LATHAN
ARCHITECTS
LATHAN ■ BRYANT ■ CALMA

ADDENDUM NO. 2
ADDITION AND RENOVATION FOR FLOMATON ELEMENTARY SCHOOL
PACKAGE A: MEDIA CENTER AND CLASSROOM ADDITION
DCM NO. 2021011 PSCA NO. 9167
Architect Job No. 21-04A
March 29, 2022

The Plans and Specifications are hereby amended. The following supersedes all contrary and/or conflicting information and is made part of the contract documents.

1 POWER PLAN
1/8" = 1'-0"

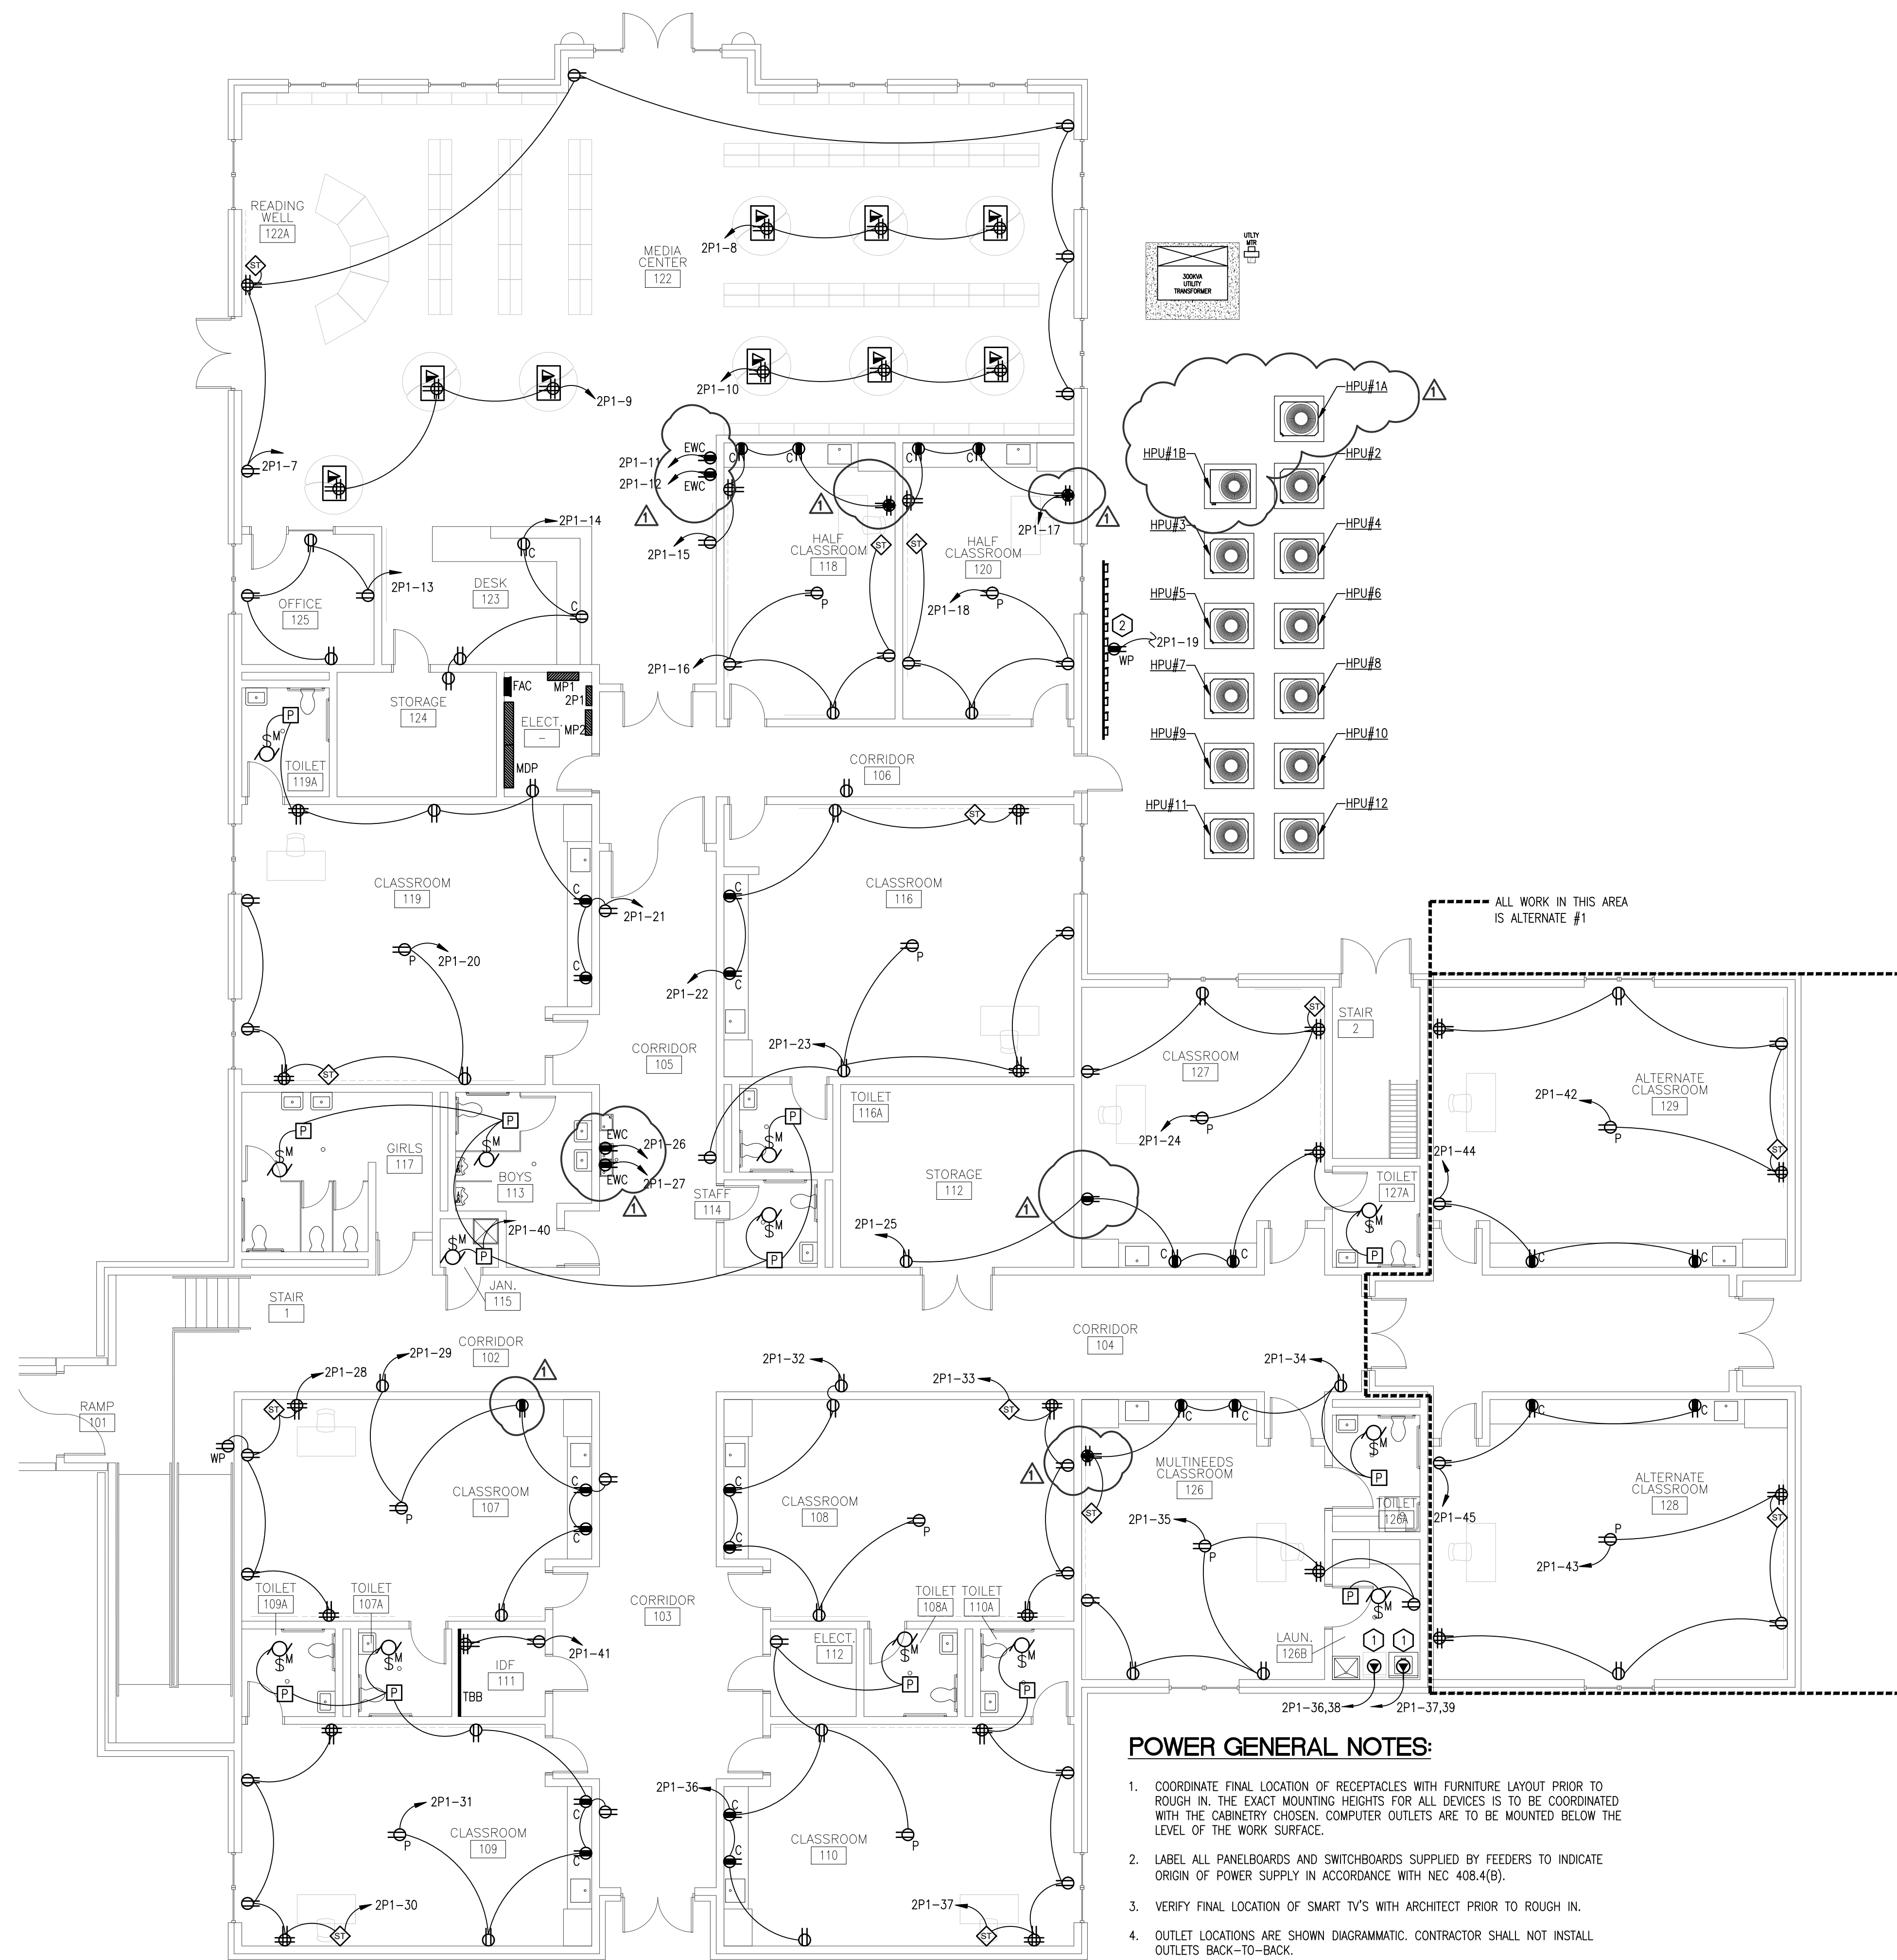
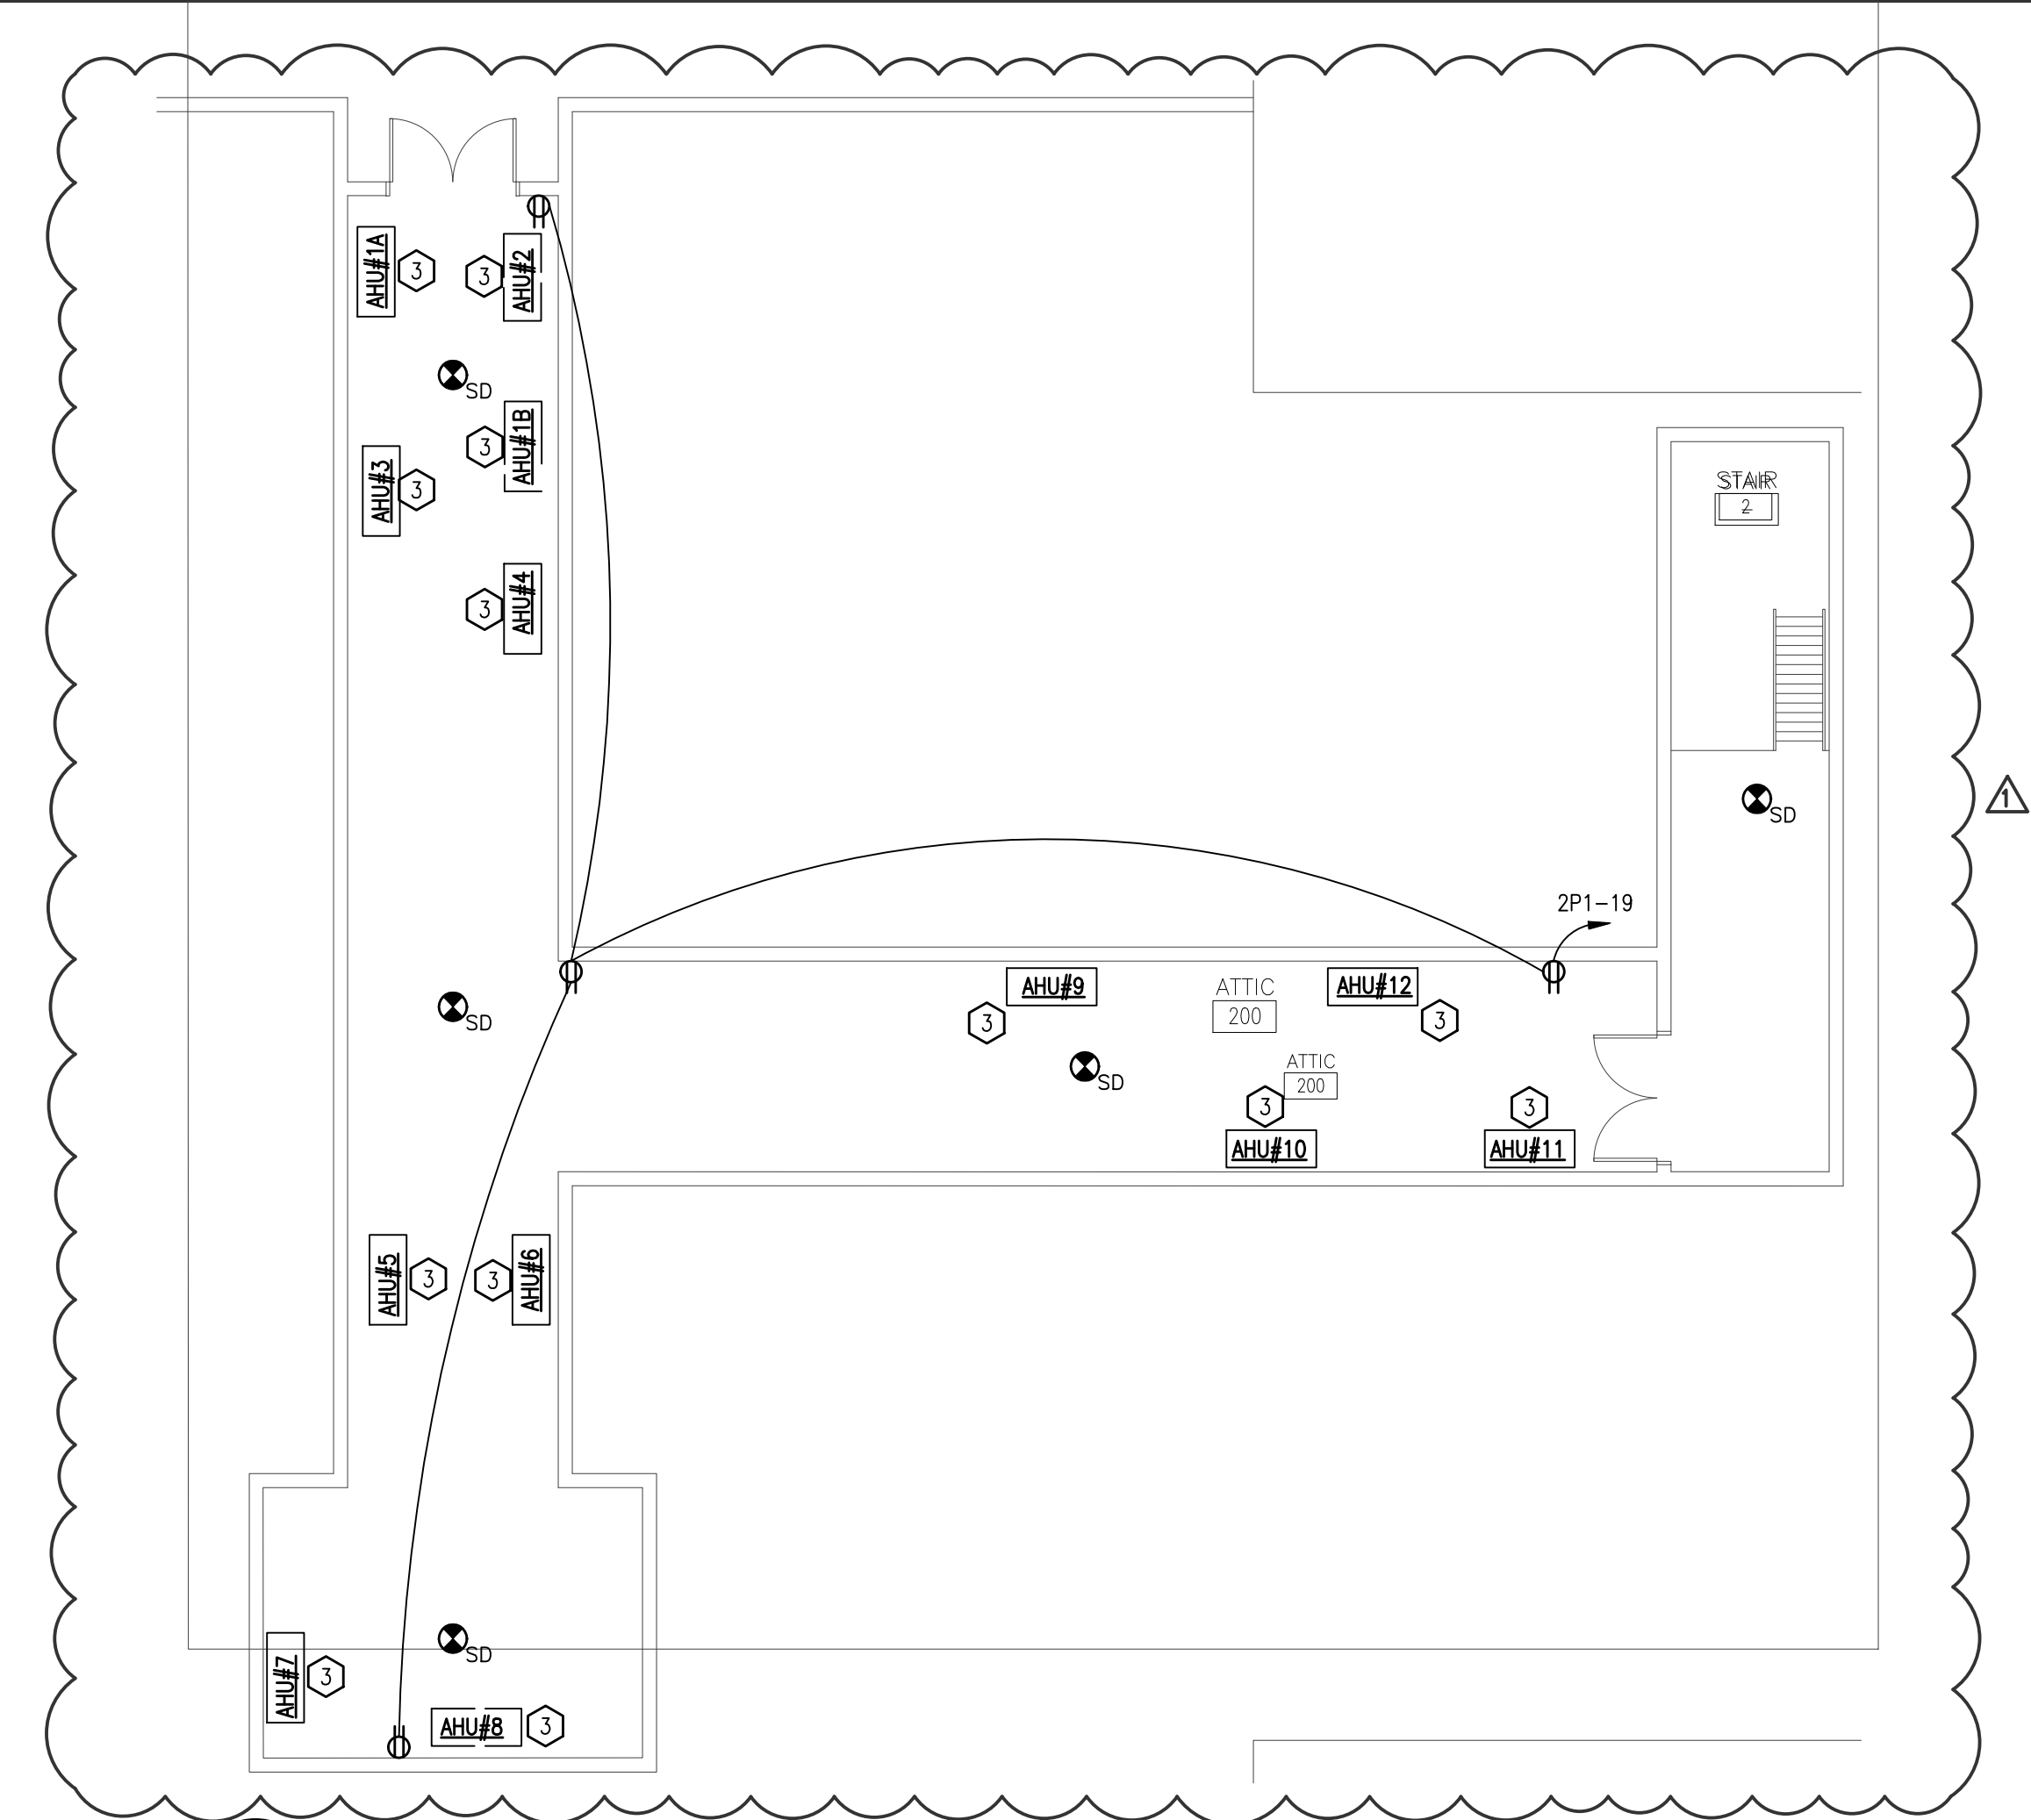
4. E2.1 – Lighting and Power Plan – GFCI receptacles have been added to electric drinking fountains (EWC), GFCI receptacles have been added within 6' of the outside edge of sinks in the classrooms referenced above, and AHU#1 has been modified.
